ENDL TEXAS

Date: 30 December 2006
 To: T10 Technical Committee
 From: Ralph O. Weber
 Subject: Security Association Model for SPC-4

Overview

Figure x1 — SA relationships

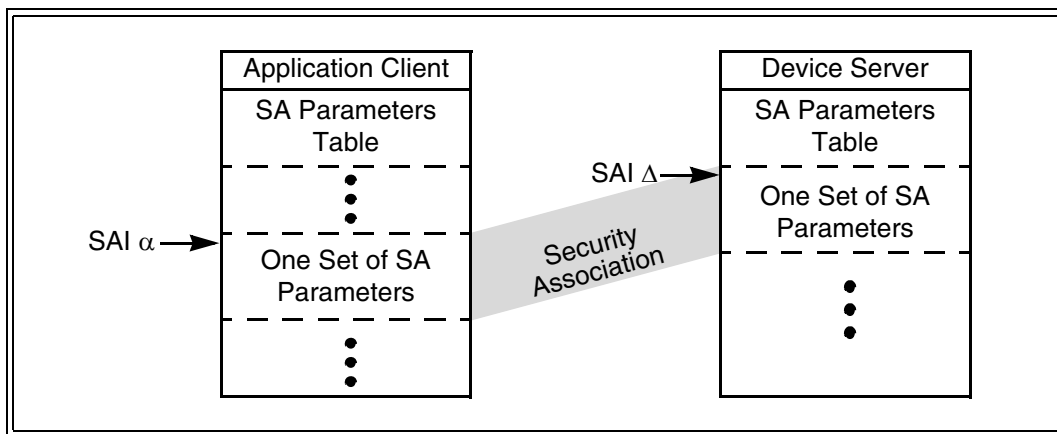
Figure x1 shows the relationship between application clients and device servers with respect to SAs.

In both the application client and the device server, the SA parameters are modelled as being stored in an indexed array and the SAI identifies one set of SA parameters within that array. The application client and device server are not required to store the parameters for any given SA in the same array locations. In order to support this implementation flexibility, a single SA is modelled as having two different SAI values (i.e., one for the application client and one for the device server).

The device server shall maintain a single SA parameters table for all I_T nexuses.

SAs shall not be preserved across a power cycle, hard reset, or logical unit reset. SAs shall not be affected by an I_T nexus loss.
